INTERNATIONAL STANDARD

AMENDMENT 1 AMENDEMENT 1

Medical electrical equipment – Part 1: General requirements for basic safety and essential performance

Figure 9 – Application of test voltage to bridged PATIENT CONNECTIONS for DEFIBRILLATION-PROOF APPLIED PARTS (see 8.5.5.1)

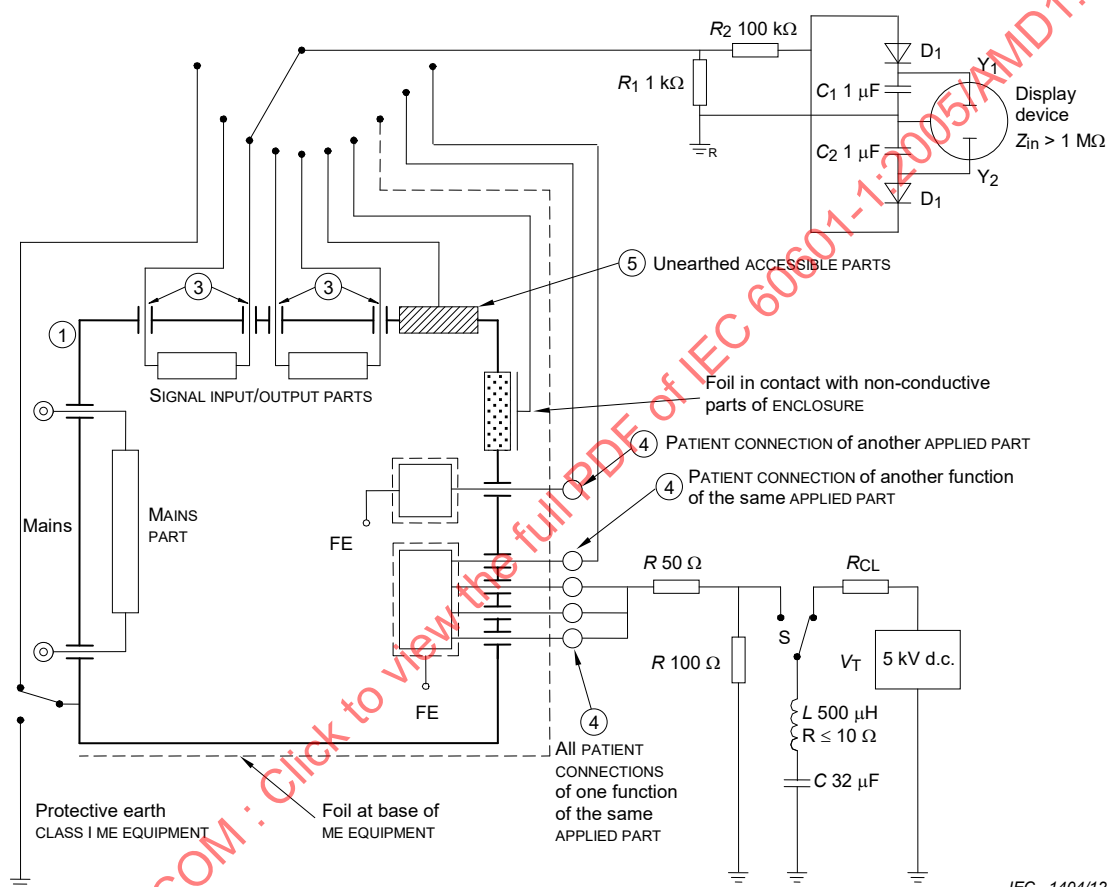
Replace existing Figure 9 with the following:

Figure 10 – Application of test voltage to individual PATIENT CONNECTIONS for DEFIBRILLATION-PROOF APPLIED PARTS
 (see 8.5.5.1)

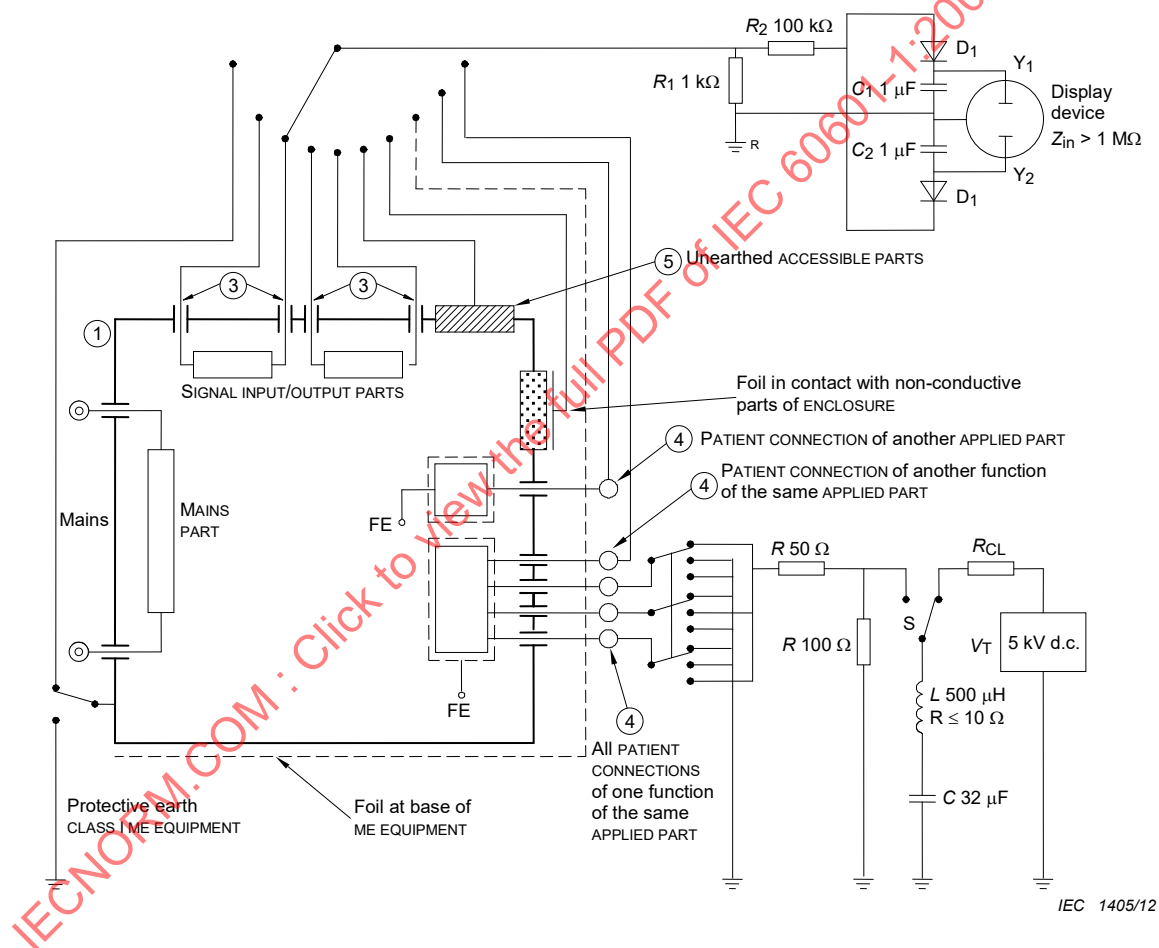
Move existing Figure 10 to immediately follow Figure 9 and replace it with the following:

Figure 11 – Application of test voltage to test the delivered defibrillation energy
(see 8.5.5.2)

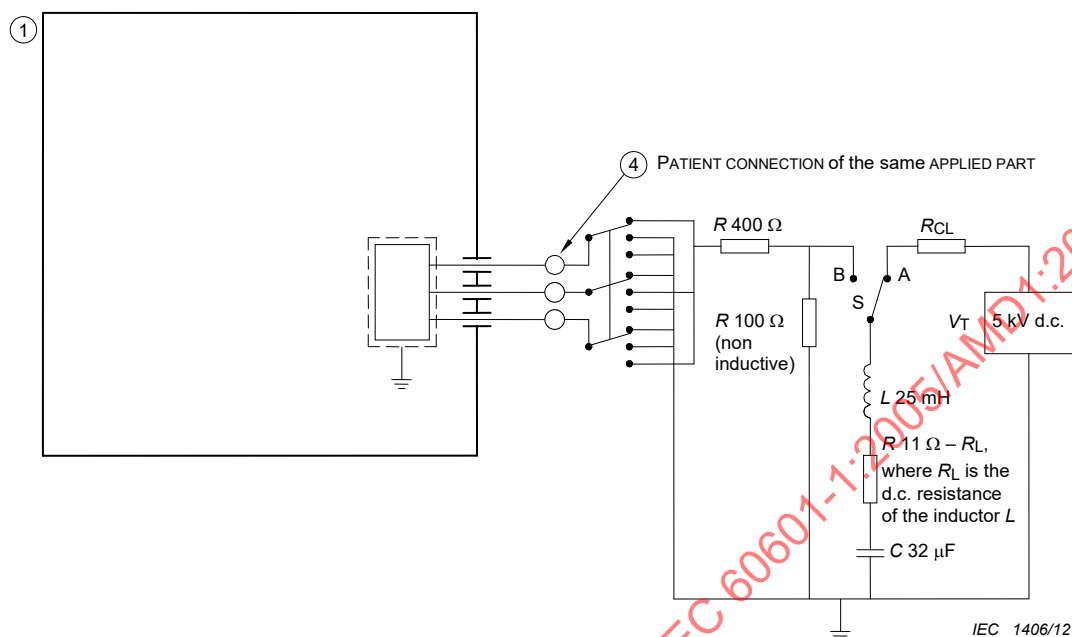
Replace the existing Figure 11 with the following:

Figure 12 – Example of a measuring device and its frequency characteristics
(see 8.7.3)

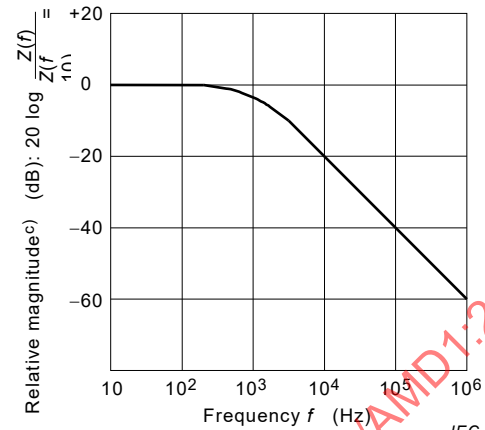
Replace existing Figure 12 with the following:

Figure 14 – Measuring circuit for TOUCH CURRENT
(see 8.7.4.6)

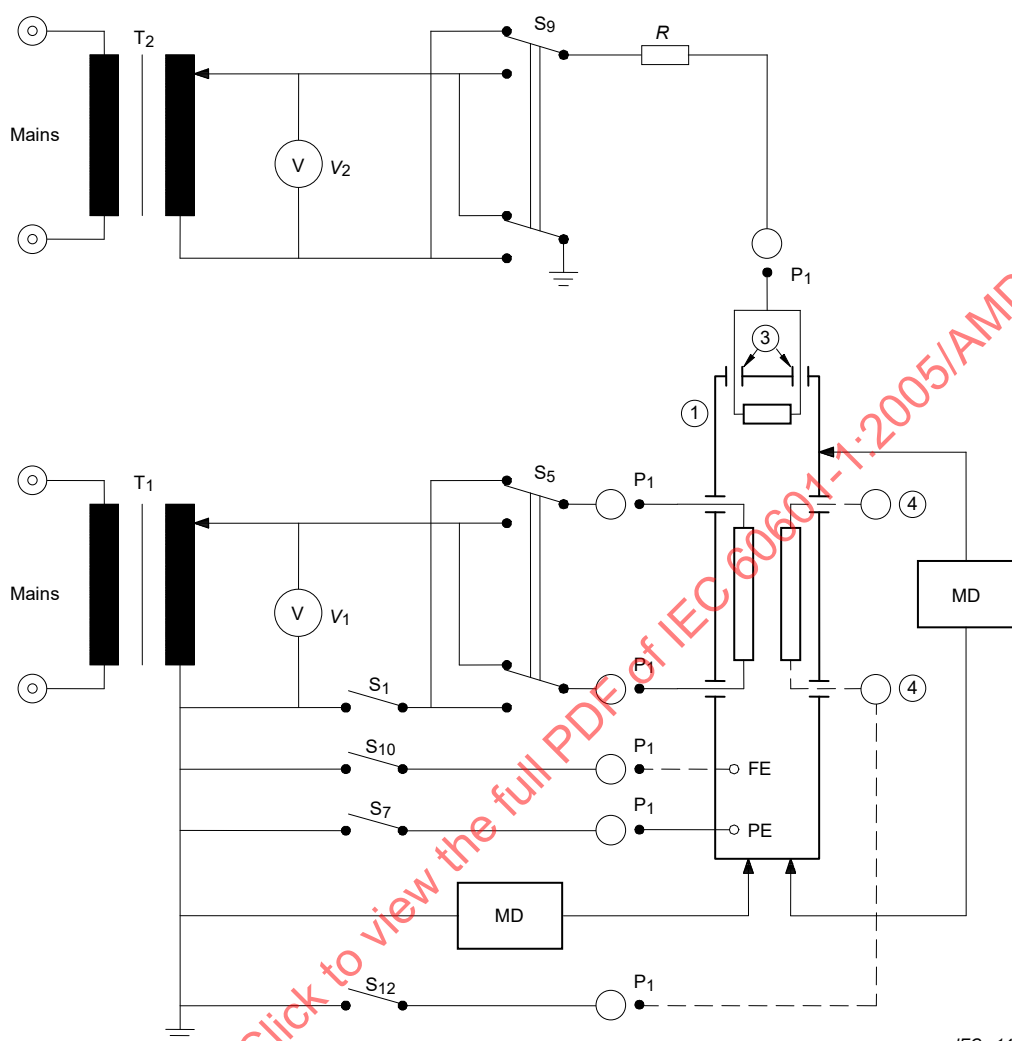
Replace existing Figure 14 with the following:

Figure 16 – Measuring circuit for PATIENT LEAKAGE CURRENT via the PATIENT CONNECTION(s) of an F-TYPE APPLIED PART to earth caused by an external voltage on the PATIENT CONNECTION(s) (see 8.7.4.7 b))

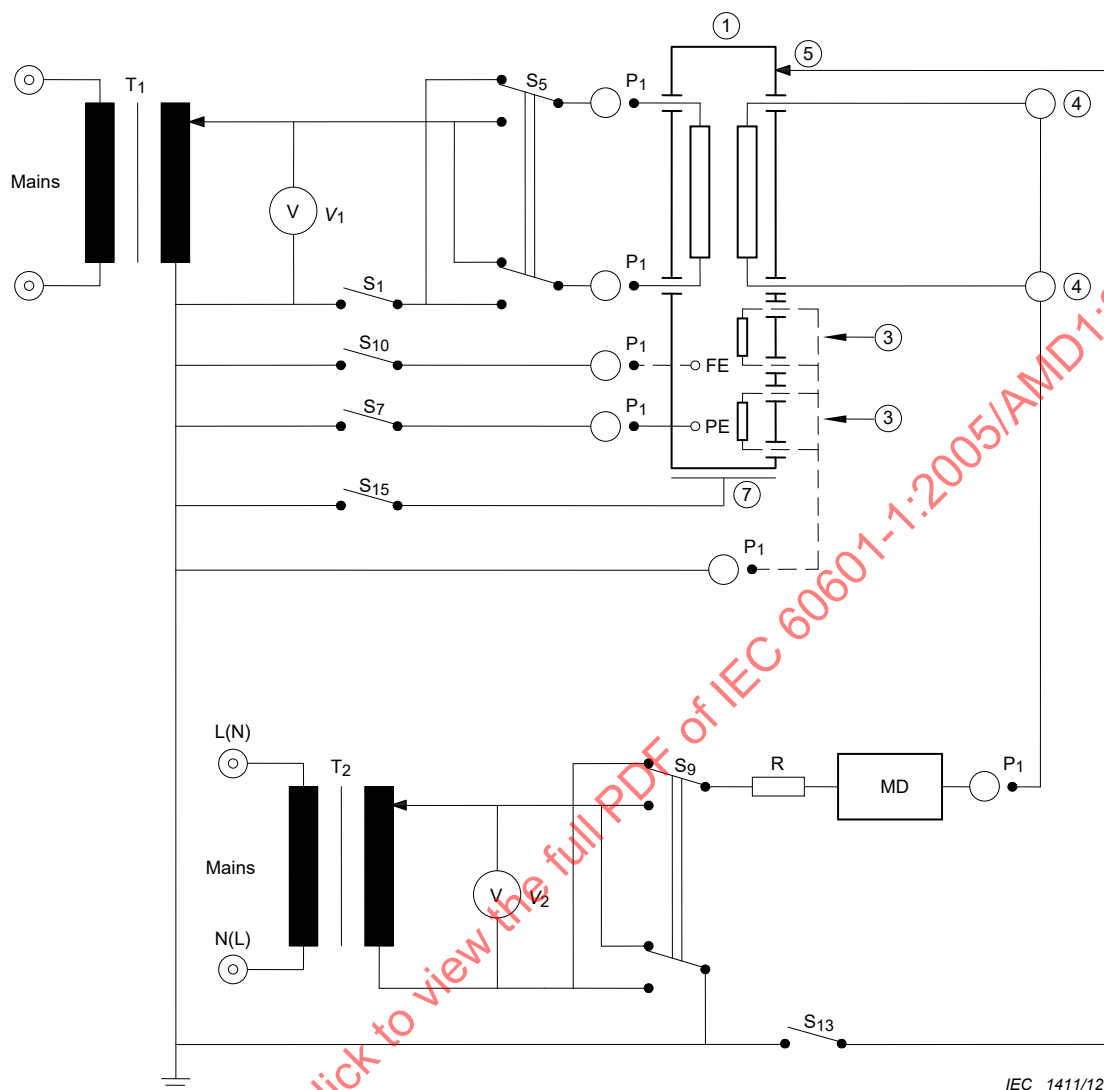
Replace existing Figure 16 with the following:

Figure 17 – Measuring circuit for PATIENT LEAKAGE CURRENT from PATIENT CONNECTION(S) to earth caused by an external voltage on a SIGNAL INPUT/OUTPUT PART
(see 8.7.4.7 c))

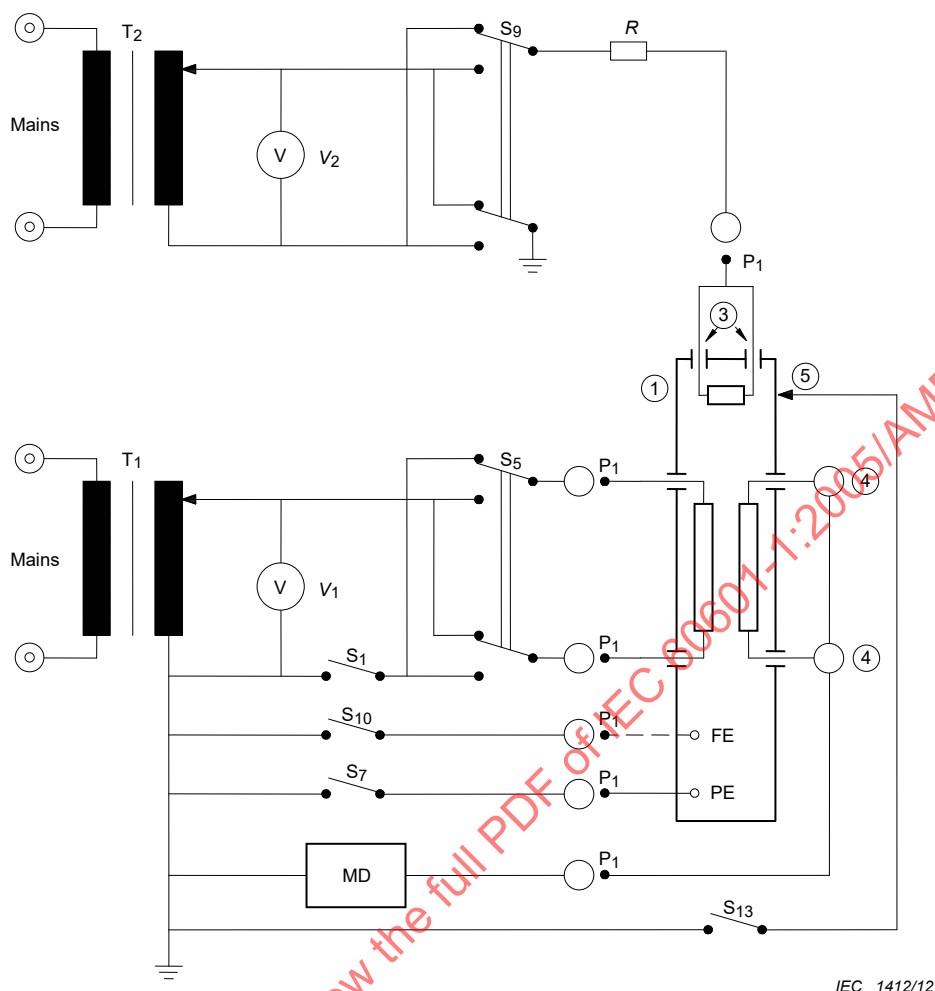
Replace existing Figure 17 with the following:

Figure 27 – CREEPAGE DISTANCE and AIR CLEARANCE – Example 6

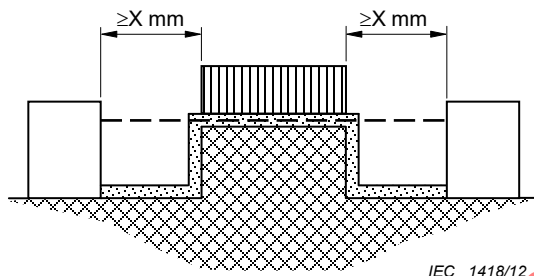
Replace existing Figures 27, 28, 29, 30 and 31 with the following:

Condition: Path under consideration includes an uncemented joint (see 8.9.3) with grooves less than X mm wide on each side.

Rule: CREEPAGE DISTANCE and AIR CLEARANCE path are the "line of sight" distance shown.

Figure 28 – CREEPAGE DISTANCE and AIR CLEARANCE – Example 7

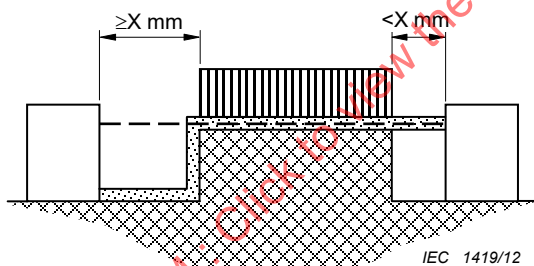
Condition: Path under consideration includes an uncemented joint (see 8.9.3) with grooves equal to or more than X mm wide on each side.

Rule: AIR CLEARANCE is the "line of sight" distance. CREEPAGE DISTANCE path follows the contour of the groove.

Figure 29 – CREEPAGE DISTANCE and AIR CLEARANCE – Example 8

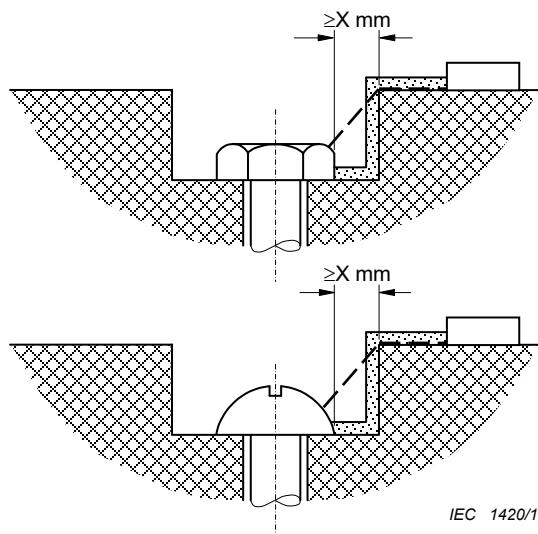
Condition: Path under consideration includes an uncemented joint (see 8.9.3) with a groove on one side less than X mm wide and the groove on the other side equal to or more than X mm wide.

Rule: AIR CLEARANCE and CREEPAGE DISTANCE are as shown.

Figure 30 – CREEPAGE DISTANCE and AIR CLEARANCE – Example 9

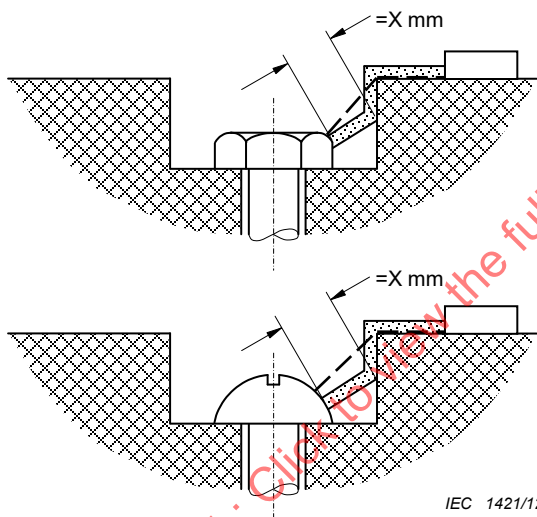
Condition: Gap between head of screw and wall of recess wide enough to be taken into account.

Rule: The AIR CLEARANCE is the shortest distance to any point on the head of the screw. CREEPAGE DISTANCE path follows the surface.

Figure A.12 – Identification of MEANS OF PATIENT PROTECTION and MEANS OF OPERATOR PROTECTION

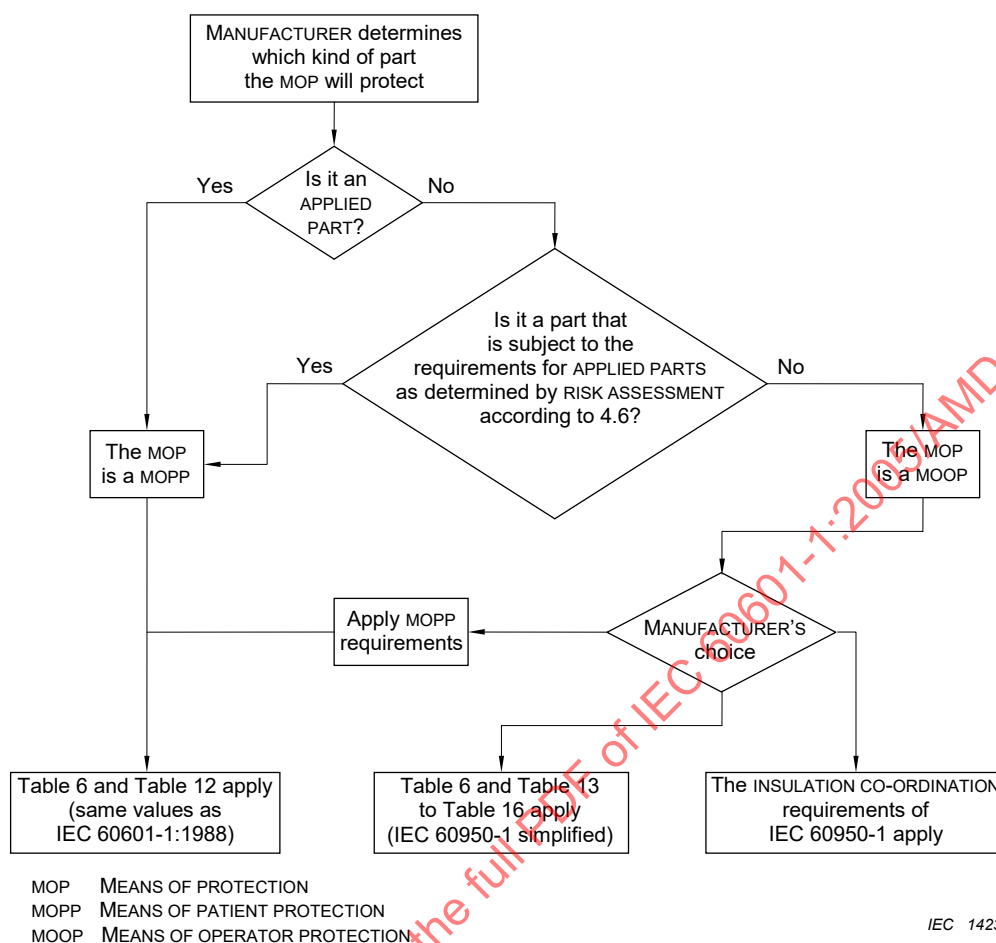
Replace existing Figure A.12 with:

Figure J.6 – Insulation example 6

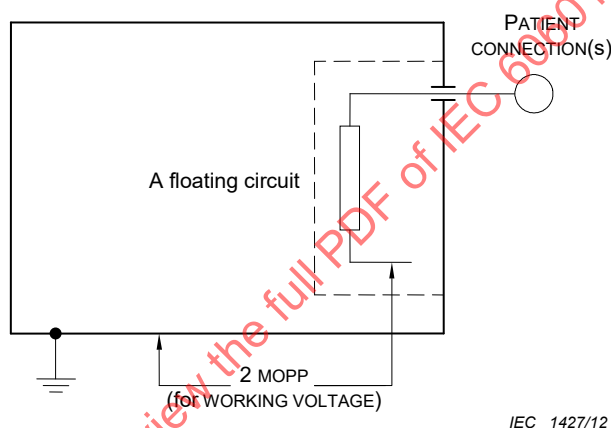
Replace the existing Figure J.6 with the following:

Figure 12 – Exemple de dispositif de mesure et de ses caractéristiques de fréquence
(voir 8.7.3)

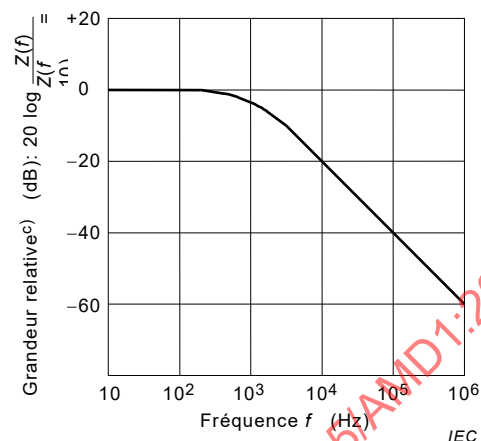
Remplacer la Figure 12 existante par la suivante:

Figure 15 – Circuit de mesure pour le COURANT DE FUITE PATIENT provenant de la CONNEXION PATIENT à la terre
(voir 8.7.4.7 a))

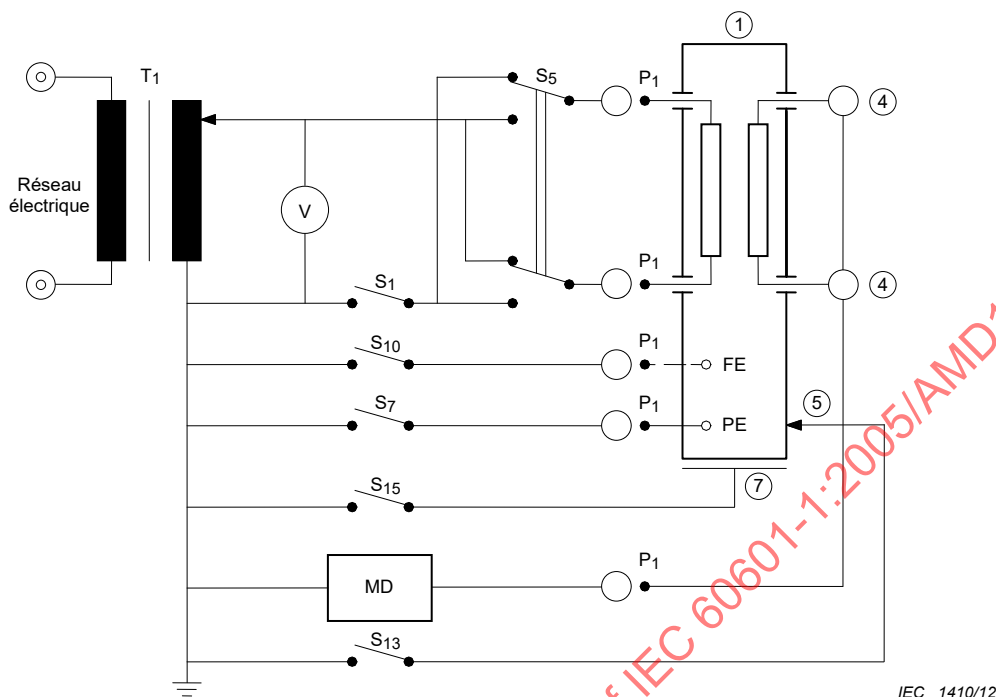
Remplacer la Figure 15 existante par la suivante:

Figure 16 – Circuit de mesure pour le COURANT DE FUITE PATIENT via la(les)CONNEXION(S) PATIENT d'une PARTIE APPLIQUEE DE TYPE F à la terre provoqué par une tension externe sur la(les) CONNEXION(S) PATIENT (voir 8.7.4.7 b))

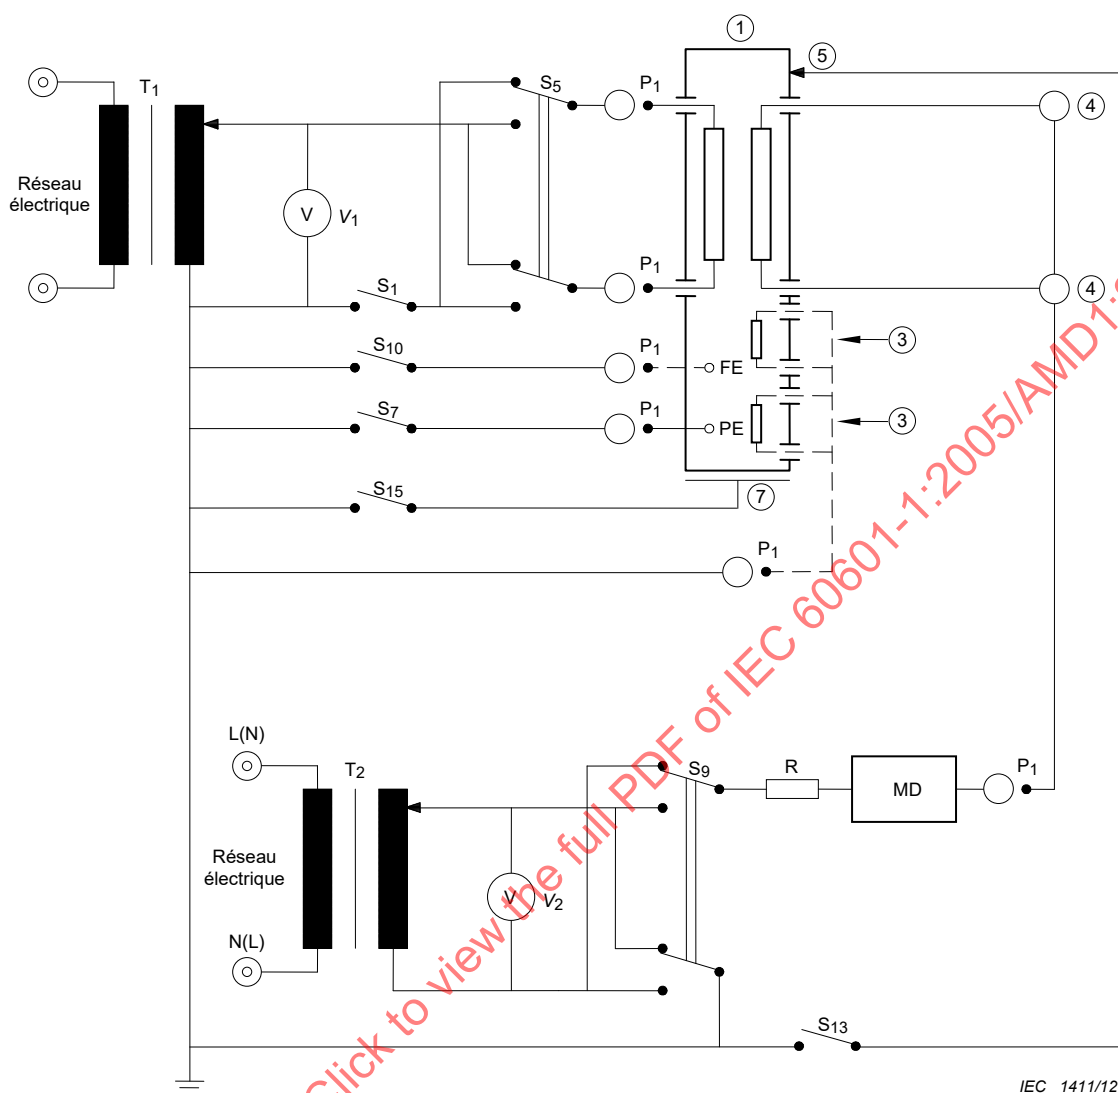
Remplacer la Figure 16 existante par la suivante:
